PROJECT : BW2
Quanta Computer Inc.

Revision History

PROJECT : BW2	
		Quanta Computer Inc.	
Size Custom	Document Number	EC RECORD A-1	
Date: Thursday, March 02, 2006	Sheet 77 of 79	Rev	3B

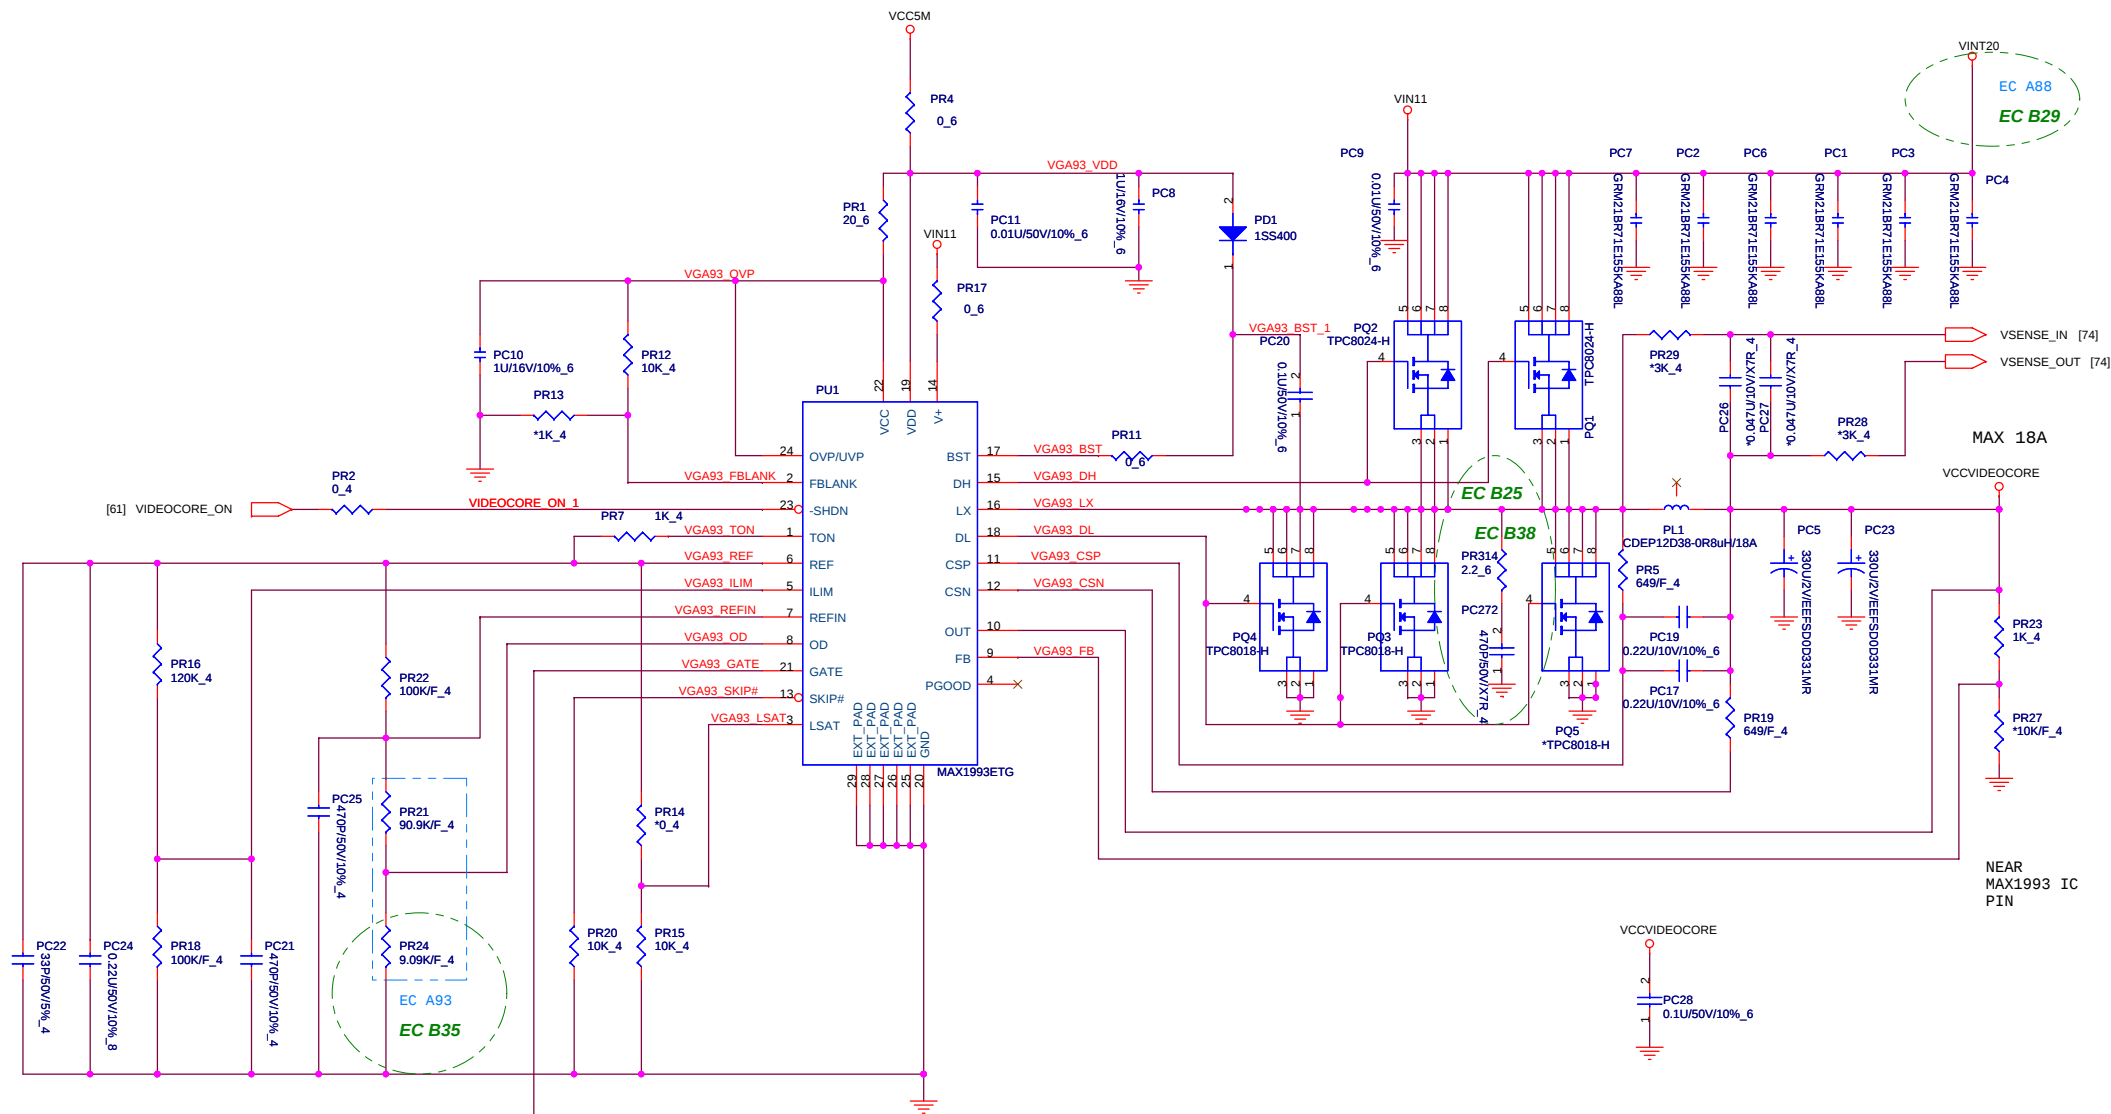
EC A93

EC B35

- EC A92/62/PR265 from 36.5K/F ohm change to 43K/F ohm.
- EC A93/67/PR21 from 100K/F ohm change to 90.9K/F ohm for M52/M54/M56, PR24 from 0 ohm change to 9.09K/F ohm for M52 and from 22.1K/F ohm change to 31.6K/F ohm for M54/M56.

- EC B33/17 Add crystal oscilator circuit. (SIT-LENOVO-036)
- EC B34/50 Add FUSE for USB hub sub card. (SIT-LENOVO-035)
- EC B35/67 Change VCCVIDEOCORE voltage. (SIT-LENOVO-034)
